**Case #:** ZBA 2018-39

***Updated* ZBA STAFF REPORT\***

**Site:** 130 Walnut Street

**Legal Notice:** 130 Walnut Street (ZBA 2018-39): Applicant, Justin Rank of 134 Walnut Street, seeks an Administrative Appeal under §3.1.9, §3.2, and §3.2.3 of the SZO and M.G.L. Chapter 40A §8 of a decision by the Inspectional Services Department (ISD) to issue a building permit for the property at 130 Walnut Street. The owner of 130 Walnut Street is Garrett Realty. RB zone. Ward 4.

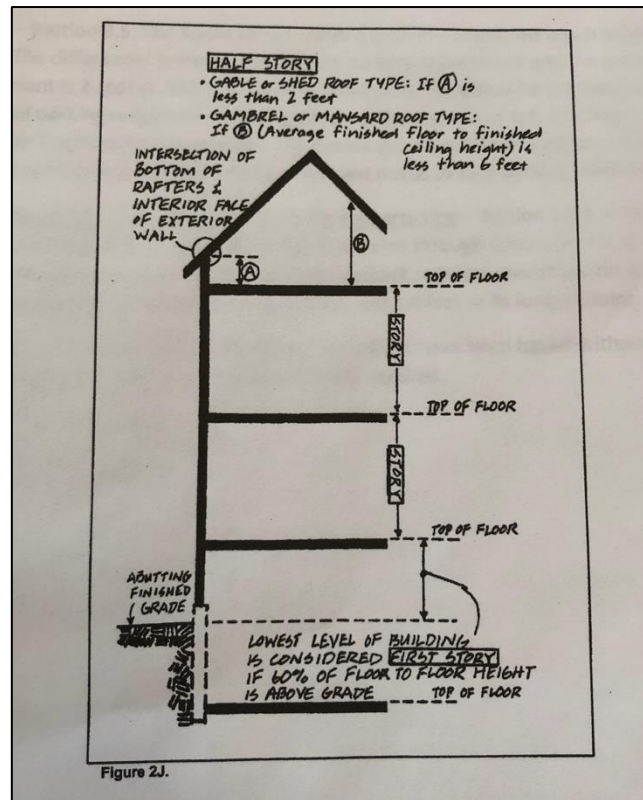
**4 - Mr. Rank alleges that:** “Dimensional Requirements – Section 2.2.14/8.5 SZO was not properly followed in determining the number of stories for the addition. The maximum allowable stories in an RB zone is three. The plans that were approved depicts a four-story building, which requires a variance under Section 5.5 (see Figure 2J of SZO) The grade immediately abutting the addition will be entirely above-ground due to the required parking configuration (after denial of

a cub cut by the Engineering Department), making it a story as described in SZO and depicted in the figure below.”

**The Definition and Figure 2E**

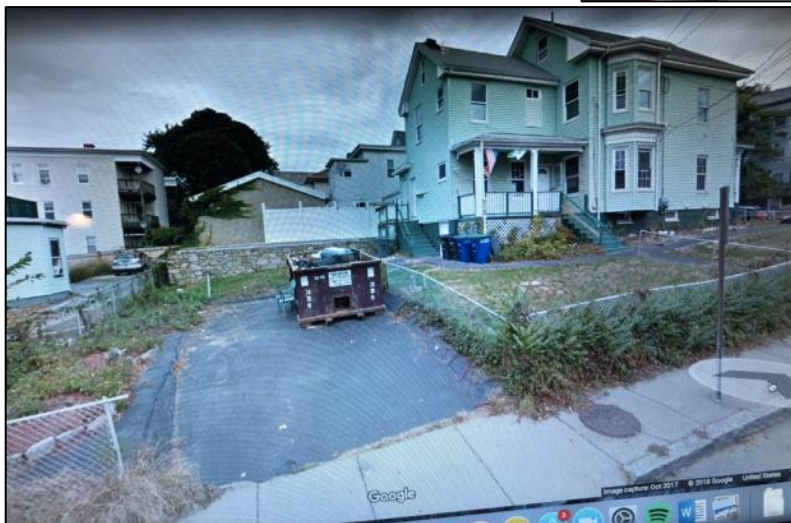
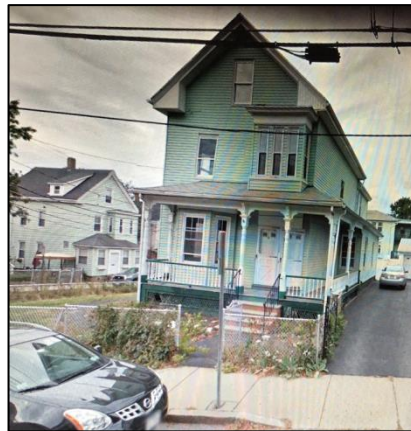
**3 - Mr. Rank alleges that:** “Grade and Height – Sections 2.2.66/8.5. the improper grade was used to determine grade and height of the building and the new addition. The approved plans use a grade and height immediately abutting the property using the formula of a site with an insignificant slope. As this property has a significant slope, the provisions of Section 2.2.66 should have been applied. Under Section 2.2.66, the finished grade to determine compliance should be measure 15’ from the building at the lowest point. This would put the building over the height allowance in an RB zone under Section 8.5, which requires a variance under Section 5.5. (see Figure 2E of SZO below).”

***Staff Response:*** In both in-person conversations as well as in his letter, Zoning Review Planner, Hans Jensen, addressed Mr. Rank’s question regarding grade and height multiple times. Planning Staff and the Zoning Review Planner both find that, despite the presence of a short retaining wall at the right rear of the property, 130 Walnut does not present a “significant slope.” Due to both natural and human-altered topography, Somerville is replete with properties containing some amount of slope to the land. As the photos below will hopefully help to illustrate, any slope to the parcel at 130 Walnut is minimal and Staff finds that the Zoning Review Planner’s application of “insignificant slope” standards to his review of the by-right application is accurate. Therefore, when determining the finished grade to the height of the building, the measurement should be taken at the finished ground elevation adjoining the building exterior walls and not 15 feet from the building at the lowest point as contended by Mr. Rank.

The purpose of this descriptor is to showcase the difference between sites where there is little to no slope (whereby height is measured based on the top sketch in the figure) to the land and those where land slopes *away from a building* (whereby height is measured based on the bottom sketch in the figure). The intent of this figure is not to demonstrate what constitutes an “insignificant slope” of land versus a “significant slope” of land.

But, Mr. Rank’s determination of “significant slope” is not relevant to the analysis. Instead, height is measured in one of two ways, as shown on Figure 2.E. The top illustration is standard, unless the underlined text in the definition of Finished Grade would apply. In that case, then the bottom illustration is used.

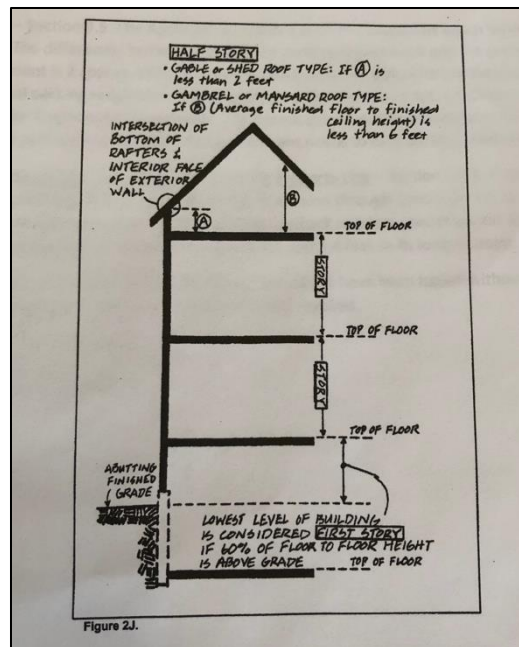
The development team has submitted two sets of documents prepared by their engineer. The first, dated March 30, 2018, and included in the ZBA packets, presents the proposed finished grade to which the development team is required to adhere. This March 30, 2018 document states that the building height, measured from the edge of the building (against the foundation) will be 33’7” at the completion of the project.

The second document presented by the development team (pages 5 and 6 of the ZBA packet) illustrates the final building height at 33' 7 7/8" when measured from the edge of the building foundation. This is consistent with the information presented in the March 30, 2018 document as well.

Even though this land does not slope, the engineer also included measurements for the final building height with the final average grade measured at 15' off of the foundation (per the second illustration in Figure 2.E). Even at this distance, the final building height of 40' complies with the height limit in the RB zoning district of 40' and complies with §2.2.63 of the SZO, above.

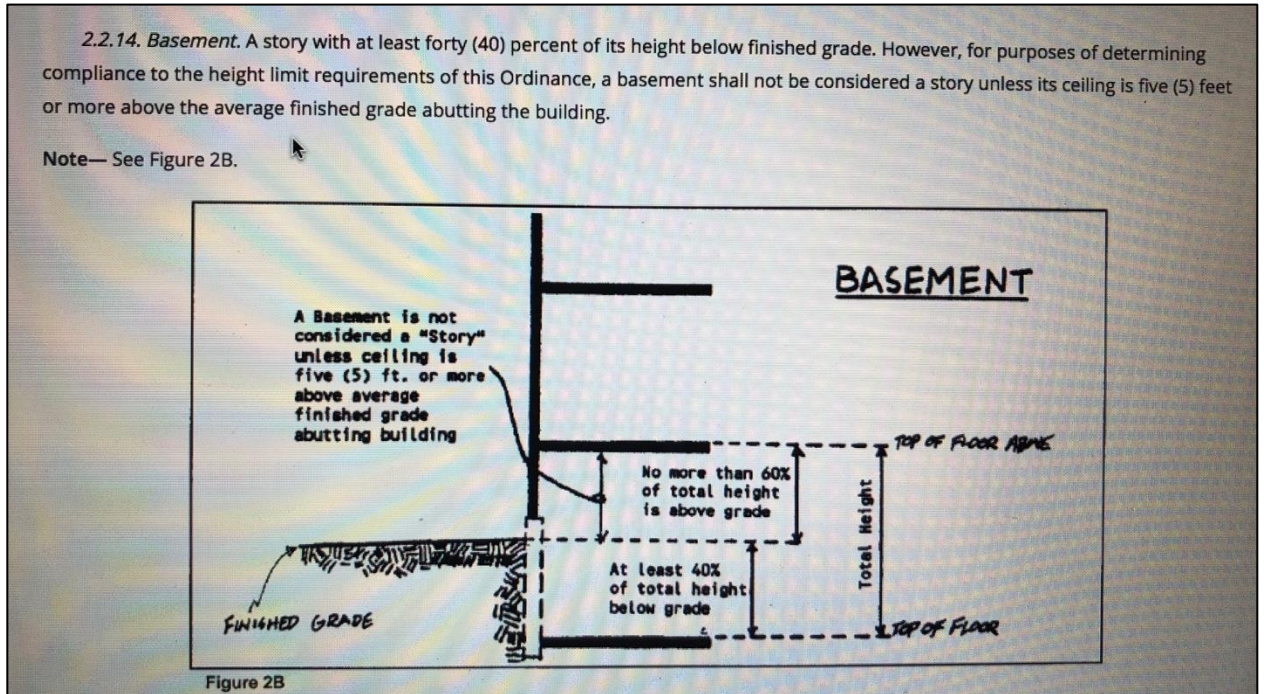
**4 - Mr. Rank alleges that:** "Dimensional Requirements – Section 2.2.14/8.5 SZO was not properly followed in determining the number of stories for the addition. The maximum allowable stories in an RB zone is three. The plans that were approved depicts a four-story building, which requires a variance under Section 5.5 (see Figure 2J of SZO) The grade immediately abutting the addition will be entirely above-ground due to the required parking configuration (after denial of a cub cut by the Engineering Department), making it a story as described in SZO and depicted in the figure below."

Staff refers the ZBA again to the document in the packets dated March 30, 2018 and to pages 5 and 6 of their packet set. Staff reiterates that the Zoning Review Planner correctly determined that the building height was correctly determined in relation to average finished grade. Staff further confirms that the Zoning Review Planner correctly determined that, in the case of 130 Walnut Street, the area at the ground level of the addition is not considered a story. As stated in §2.2.14:

In the stamped statement of March 30, 2018 provided by the development team’s engineer, it is stated states that the distance of the basement ceiling above grade will be 4’1”<sup>2</sup>, thus below the five foot limit outlined in this section of the zoning. Staff reminds the ZBA that an applicant must comply with all such statements in their submitted documents. At the end of the project, if the development team does not comply with the ceiling height requirement based on the average finished grade abutting the building, then no Certificate of Occupancy (CO) shall be issued.
